**-Addendum-**  
**To**  
**Critical Area Study**  
**and**  
**Watercourse and Wetland Buffer Reduction**  
*of the*

*Valentin Property*  
4350 E. Mercer Way  
Mercer Island, WA 98040

*Dated: October 1, 2021*

**DRAINAGE / CIVIL PLAN**  
VALENTIN RESIDENCE  
4350 E. MERCER WAY, MERCER ISLAND, WA 98040

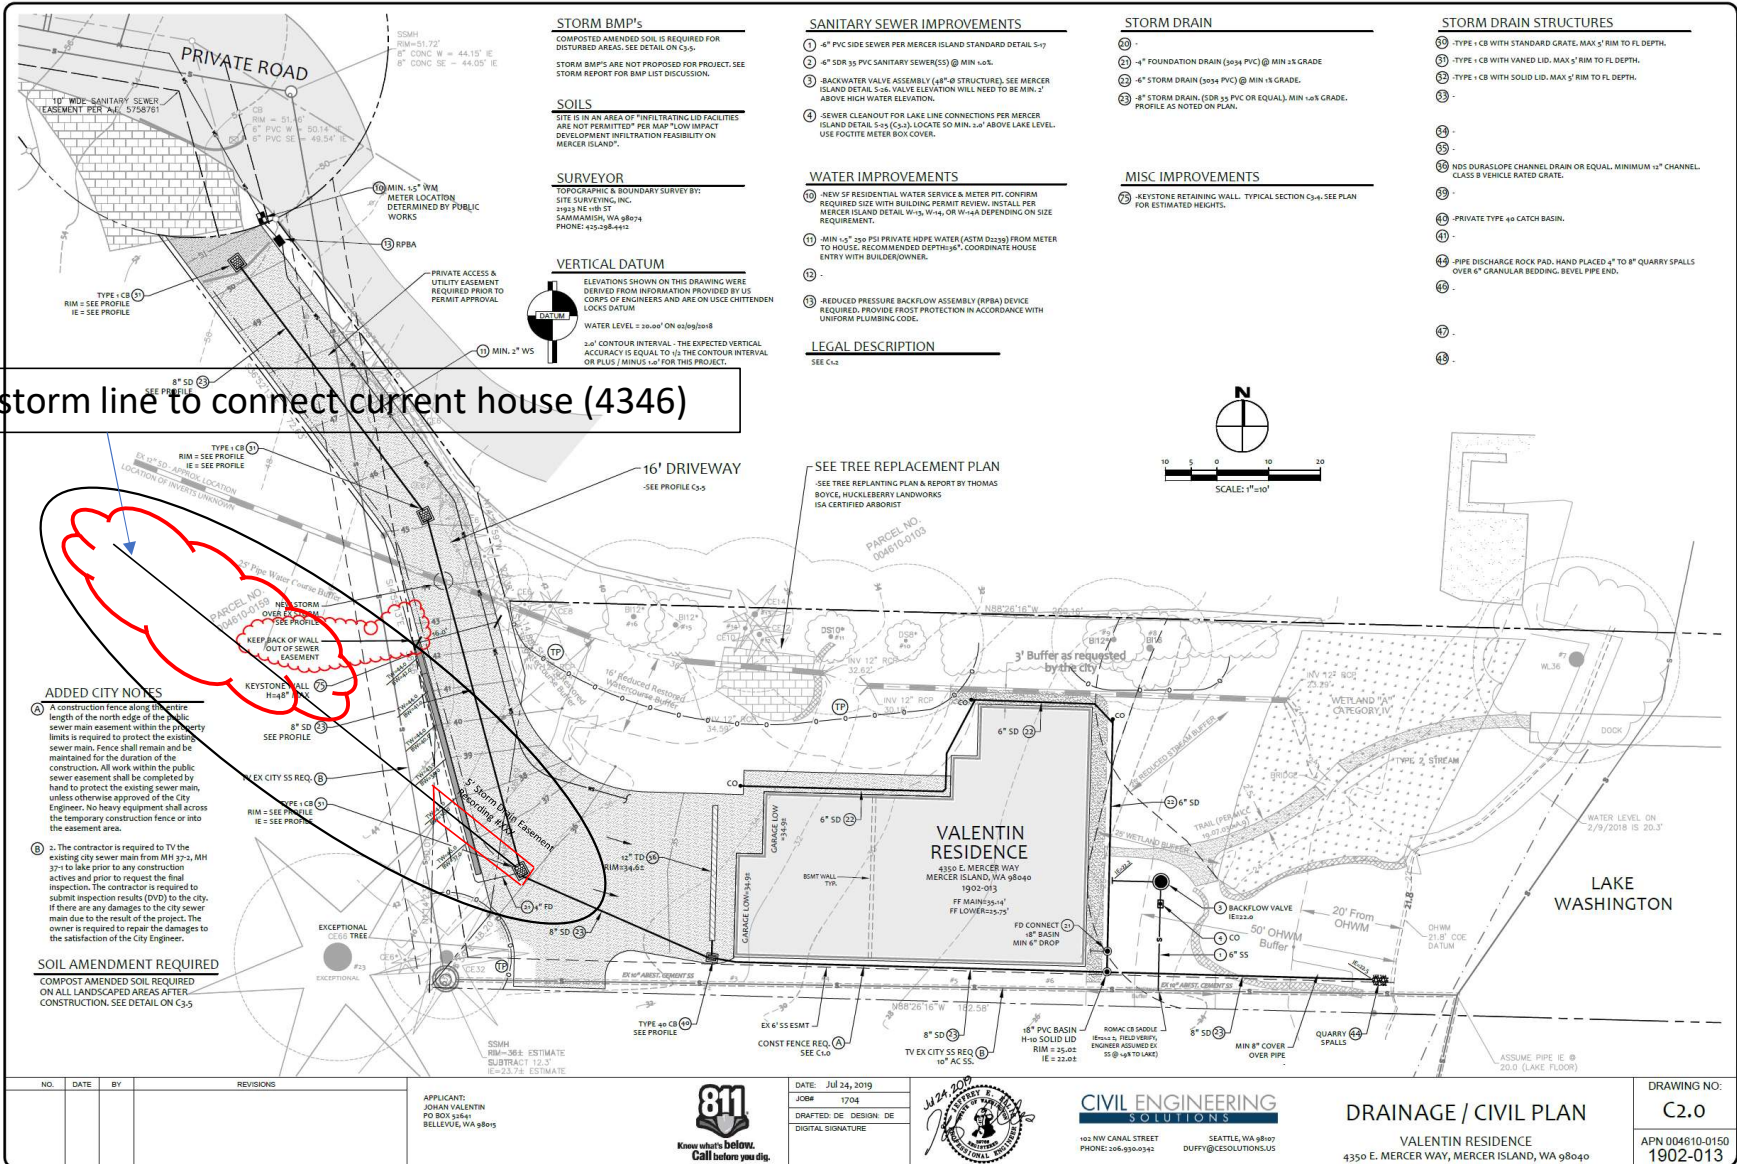
Add 6" storm line to connect current house (4346)
